MEETING NOTICE – SITE REVIEW COMMITTEE

Date/Time: Wednesday September 21st 2022 (5:30 P.M.)

RE: 3828 Packerland Dr., HB-950-7; New 11,890 Square Foot Industrial Building, office/shop/warehouse with associated site improvements

ISSUE: Discussion and action on a new 11,890 square foot commercial building and associated site improvements

LANDSCAPE PLAN

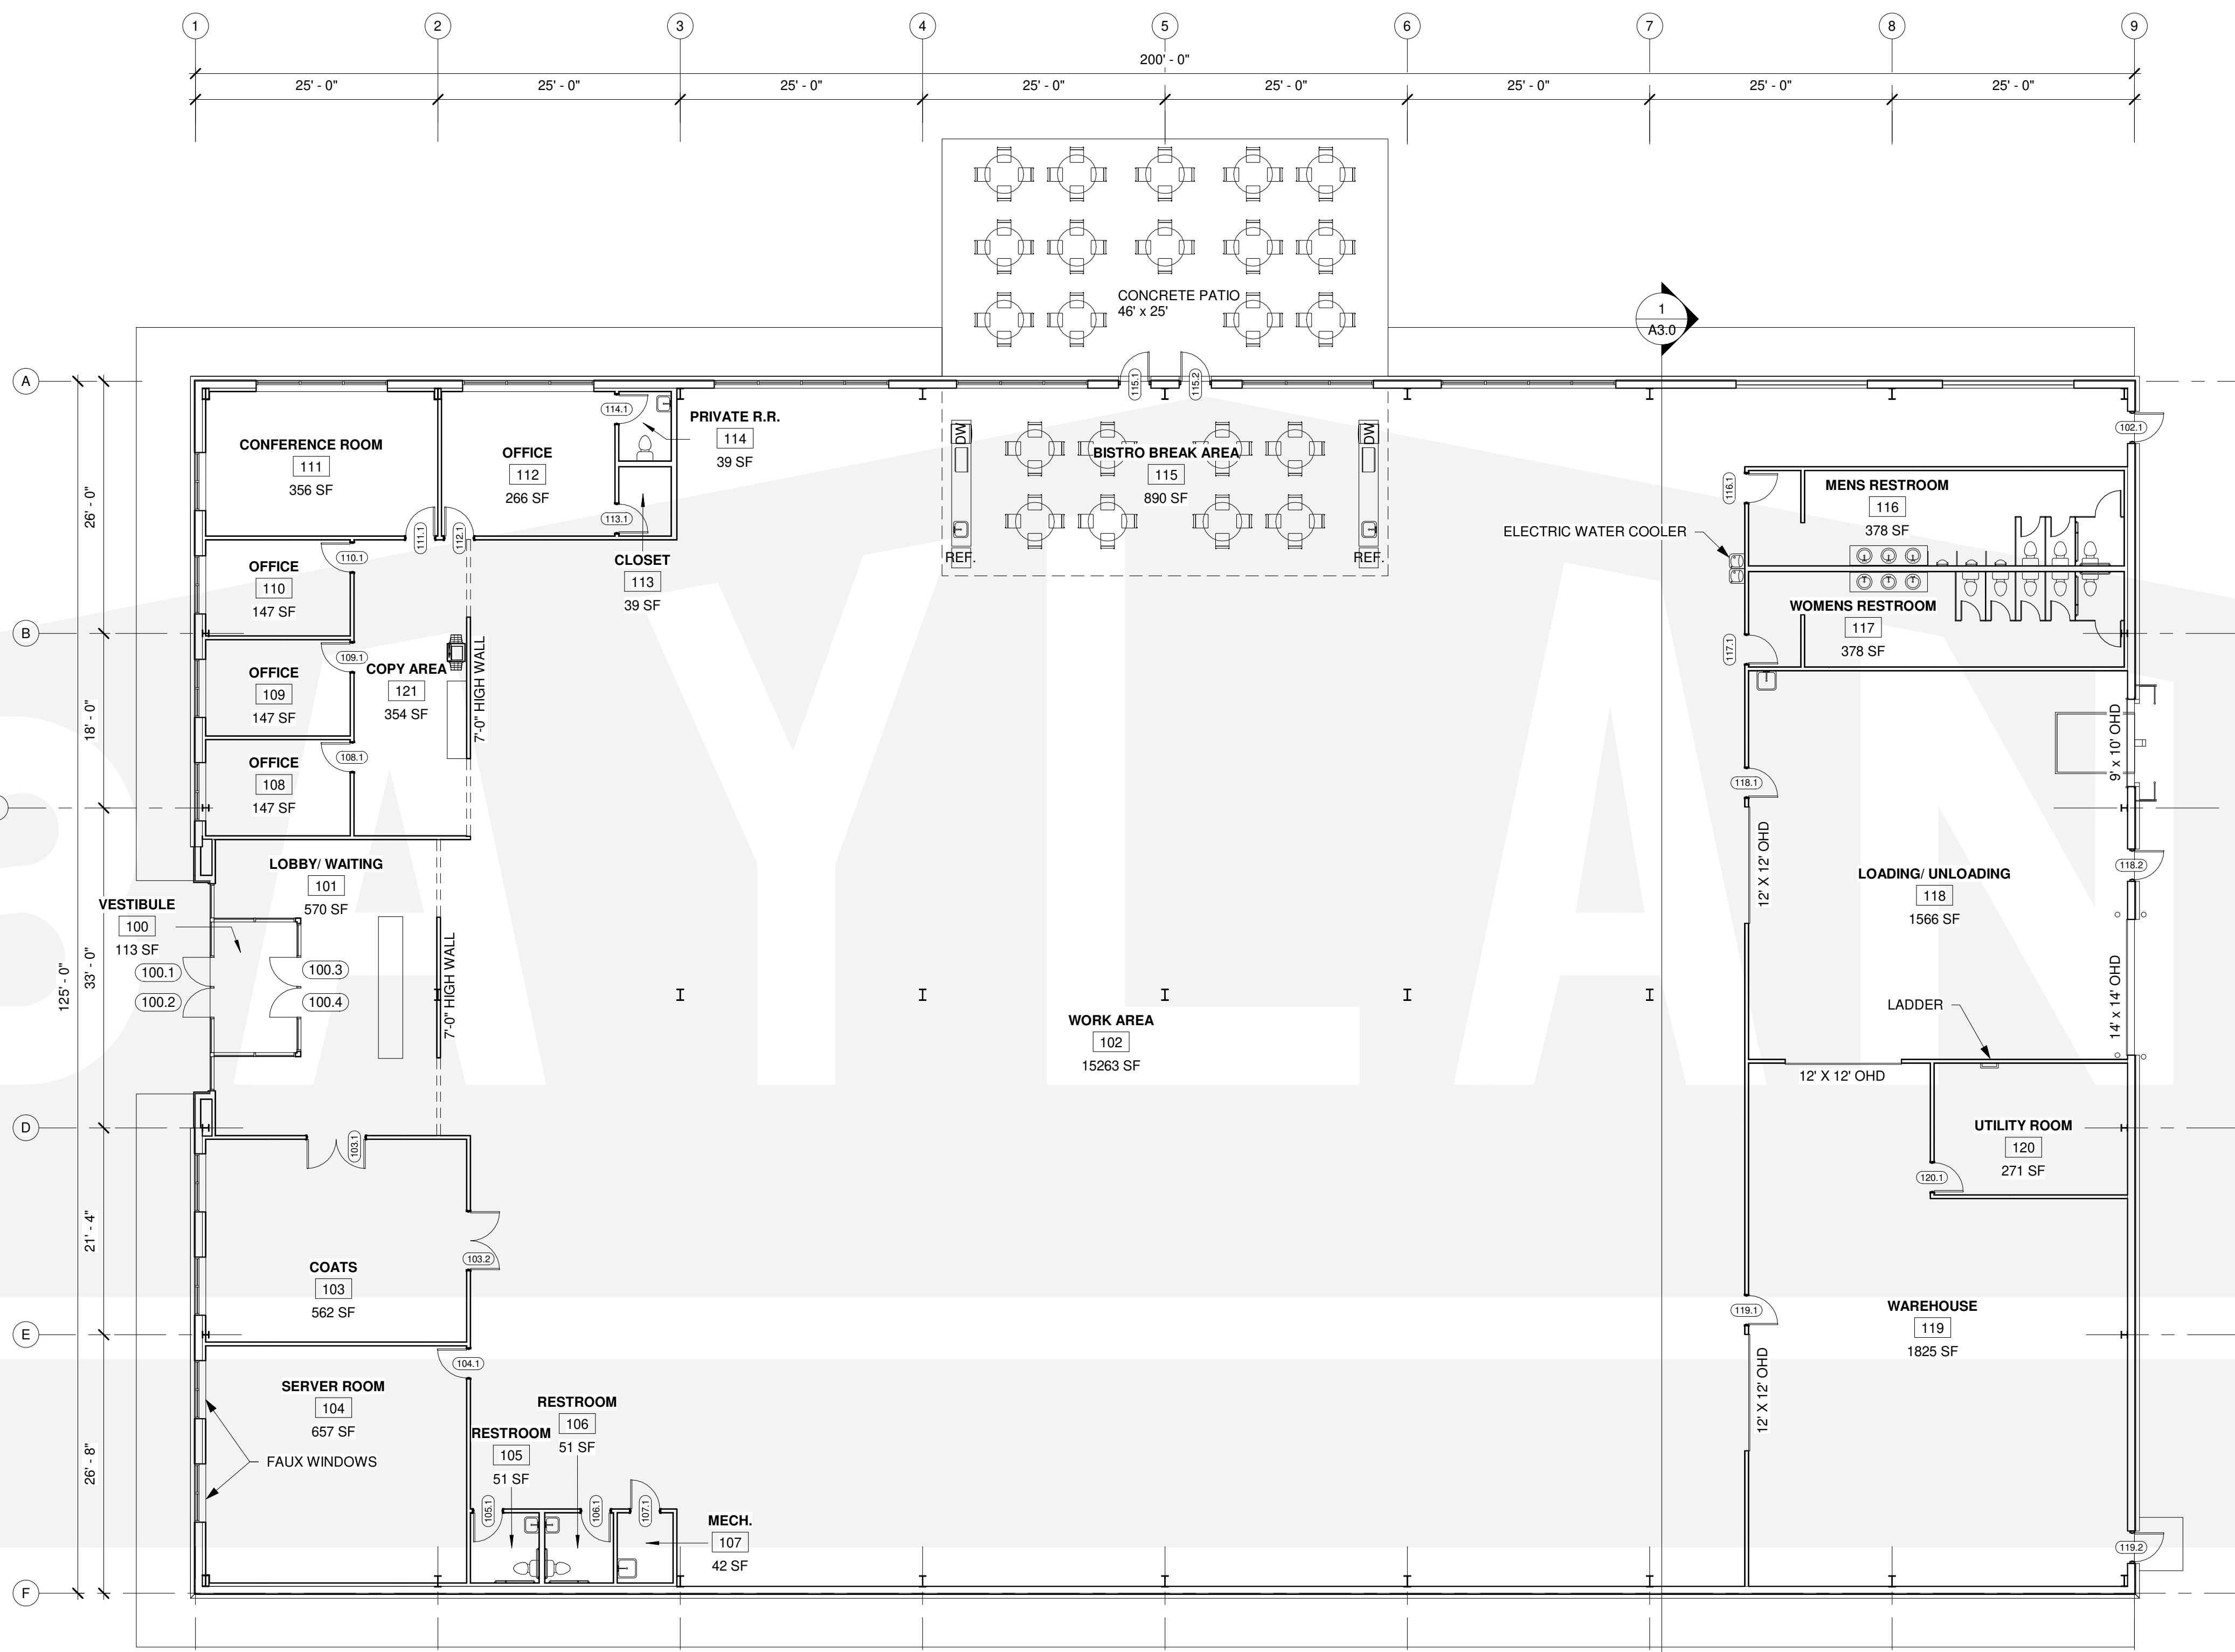
Section 3, Landscaping Plan: Required tree planting along the public roadway is noted on plan, however, a additional landscaping is recommended around the refuse/recycling enclosure and ground mounted mechanical equipment/backup generator to provide better screening of these areas.

1. Detailed on construction materials of refuse/recycling enclosure that are compatible with the primary building.
2. Additional landscape planting around south side of mechanical equipment /generator area and along south and east sides of refuse/recycling enclosure to screen from view from the public roadway.
3. Maintaining visual site lines for vehicular and pedestrian traffic at driveway accesses along Larsen Orchard Parkway.
4. Signage details shall be submitted for approval prior to installation.
5. Any additional mechanical equipment if located on the roof or ground, shall be screen from view by materials compatible with the building or landscaping.

1 / A2.0 SCALE = 1/8" = 1'-0"
WEST ELEVATION

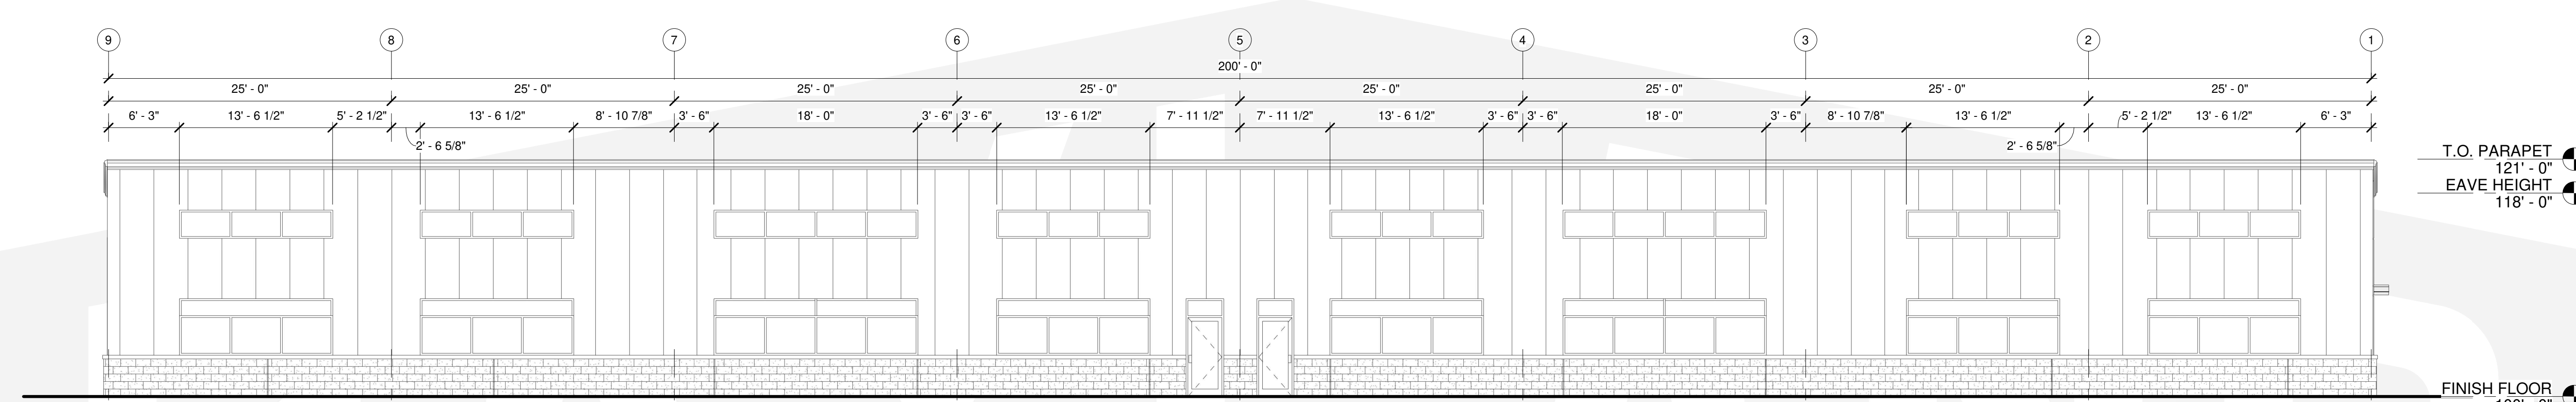
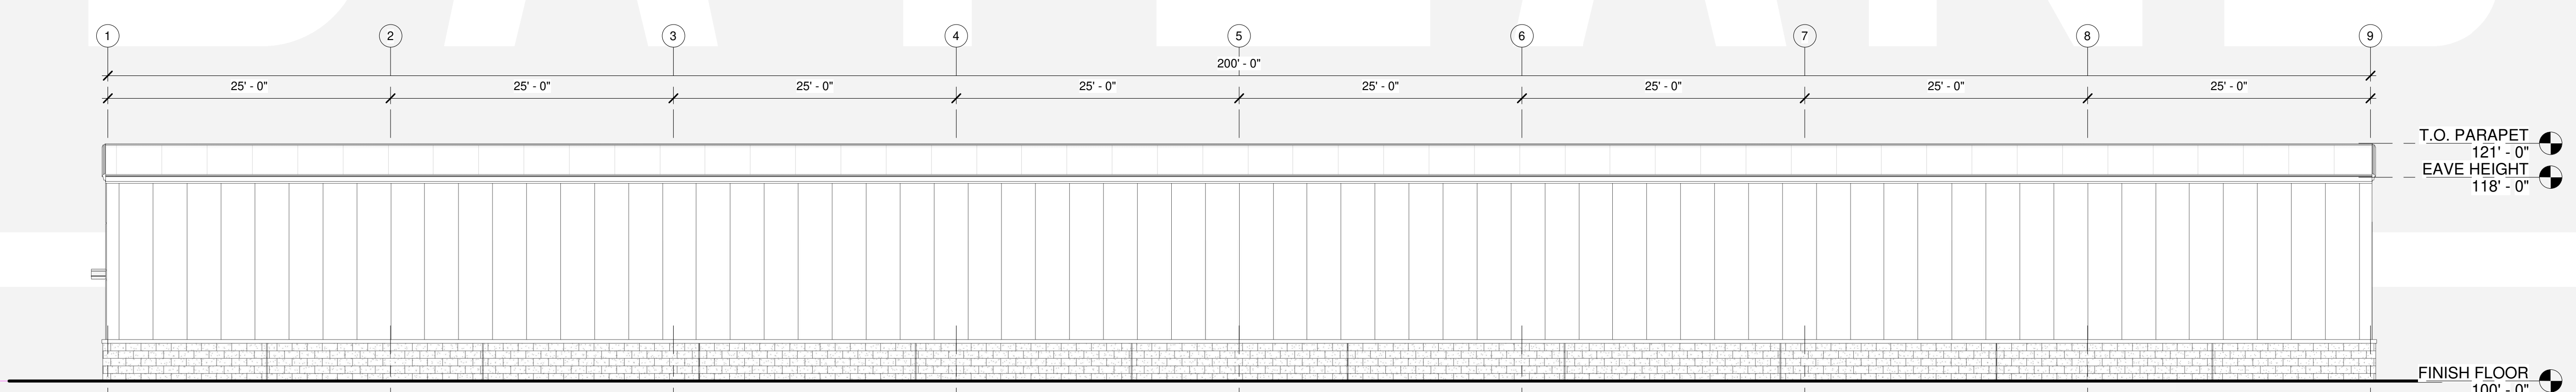
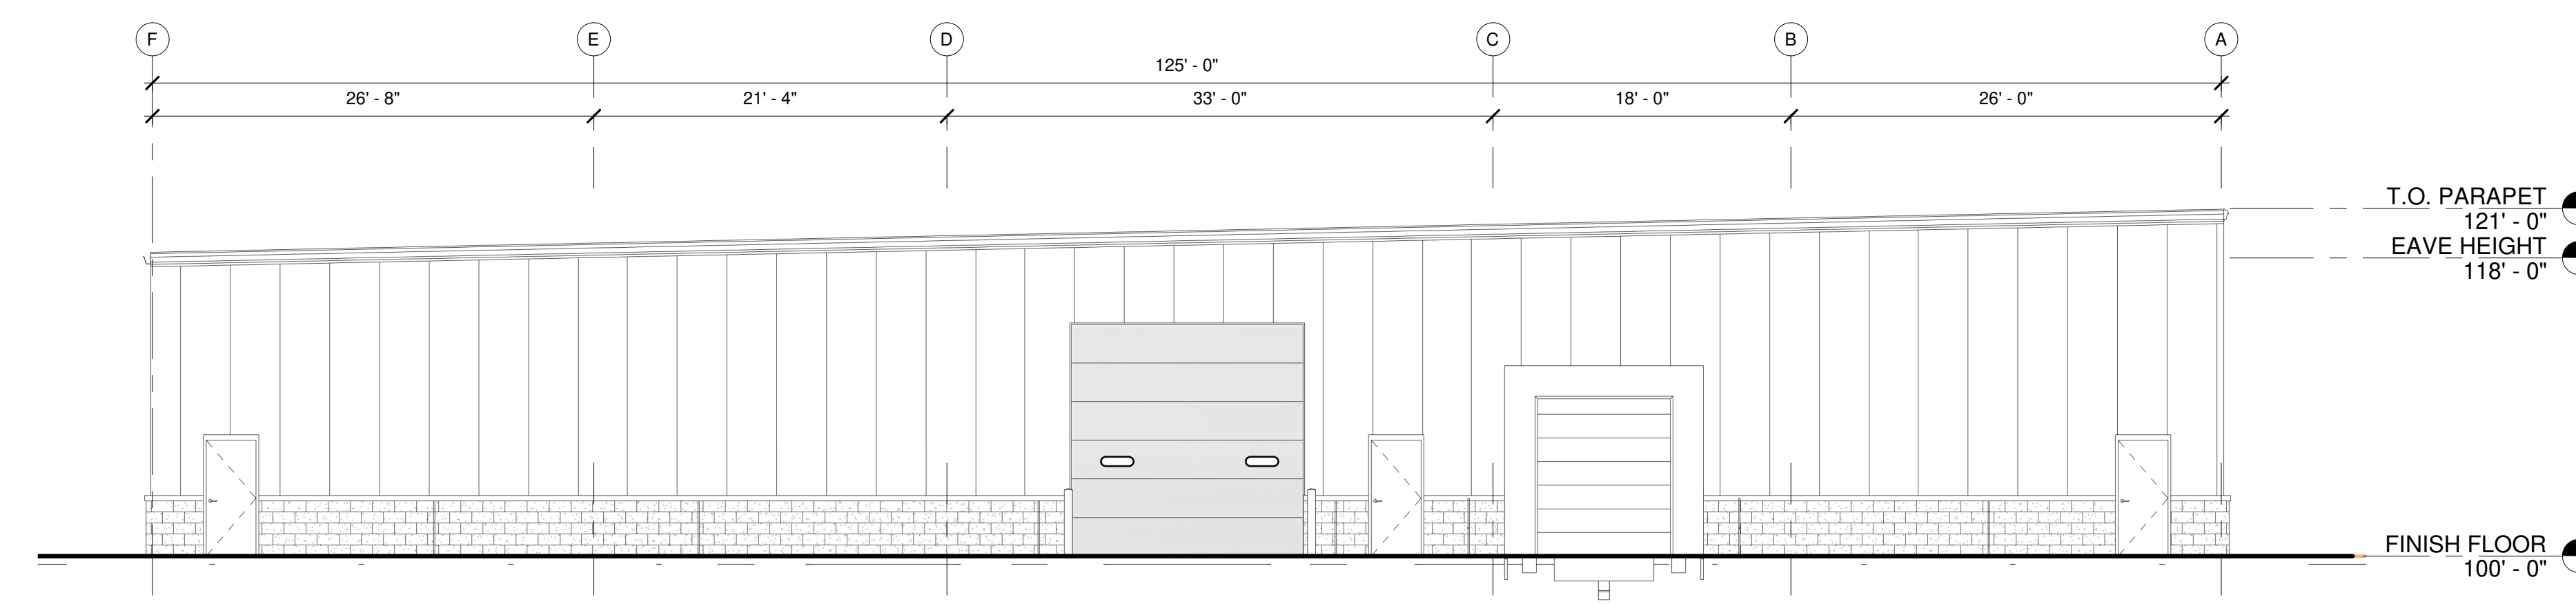
1. **Materials:** Metal framed building.
2. **Exterior Materials:** Proposed building materials consist of pre-finished smooth metal wall panels with 3'-8" high 4" spilt faced block veneer wainscoting on all four building elevations with pre-finished ACM panels around main entrance area on the front elevation.
3. **Height:** 21' to top of parapet wall
4. **Overhead doors:** Located on east elevation of building along Larsen Orchard Parkway.
5. **Mechanical equipment:** Mechanical equipment and backup generator are noted adjacent to the rear of the building and additional planting are recommended to screen the equipment from public view.
